Final Report Technical Review of FEMA CCAMP for Ventura County

The County of Ventura

moffatt & nichol

August 2017

Figure 5-28: Transect 20/533 Profile and Runup Parameters

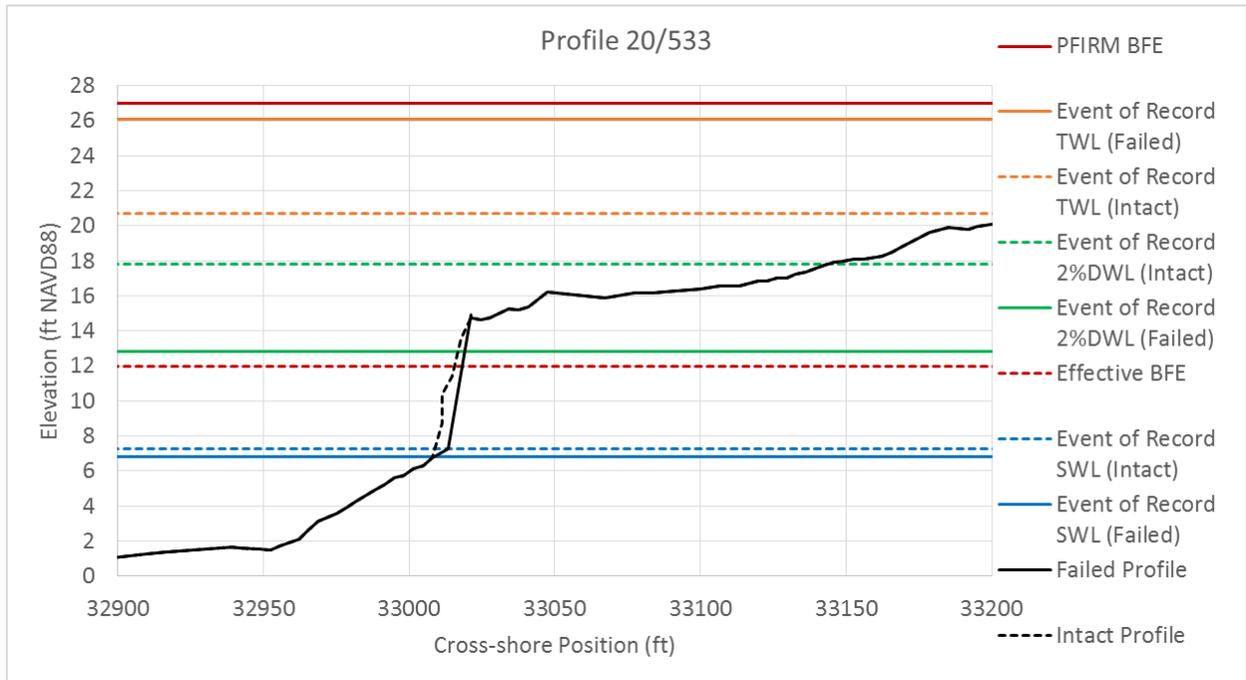
- Bore overtopping was calculated and mapped in a secondary VE zone at this transect since inland propagation exceeded 35 ft. If TWLs are reduced, overtopping would be recalculated and as a result, inland propagation and flood depths may be reduced.

Figure 5-35 : Cross Shore Beach Profiles at Transect 40

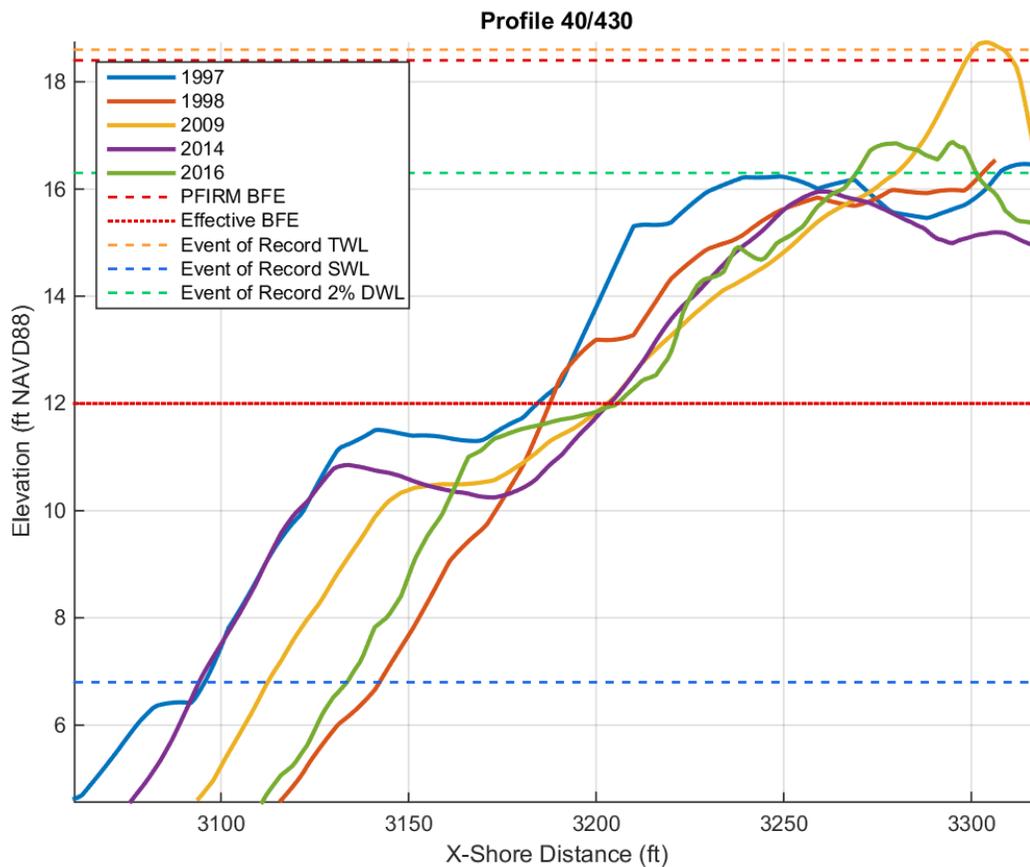
Preliminary FIRM base flood elevation exceeds all dune crests in the historic record except for the 2009 LIDAR data. Cross shore beach profiles at Transect 40 are shown in Figure 5-35.

Figure 5-46: Cross Shore Beach Profiles at Transect 51. Note that PFRIM BFE and Event of Record TWL are at the same elevation, 18.3 ft.

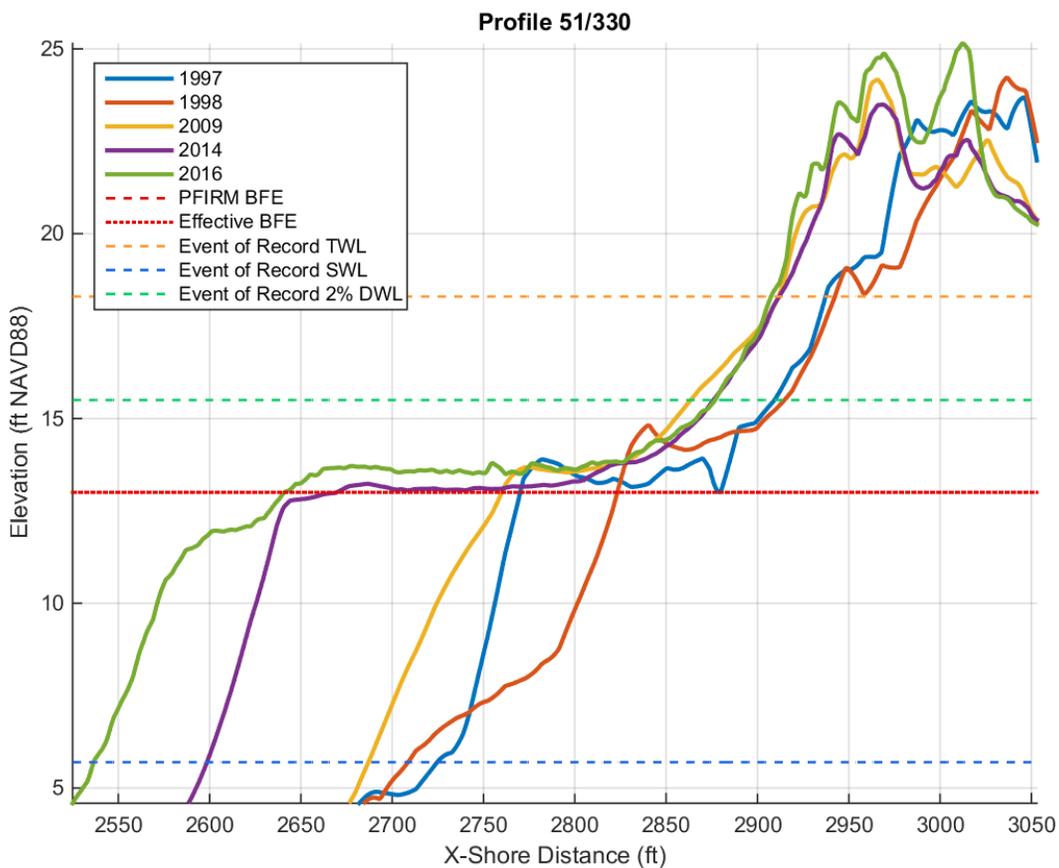
- Bore calculation completed using a DWL2% over the crest elevation. FEMA used a DWL2% of +18.3 feet and a crest elevation of 26.0. Geomorphic analysis on available topography showed an average crest of 21.4 feet and a range of 20.3 - 22.5 feet.
- Storm caused changes during the 1997-98 El Niño (October to April):
 - Beach width narrowed by 12 feet
 - Dune was stable
- Between 1997 and 2016, the long-term changes were:
 - Beach width (MHW to crest) widened by 123 feet
 - MHWs shoreline change accreted by 157 feet
 - Dune increased in elevation by 1.5 feet and migrated seaward by 34 feet
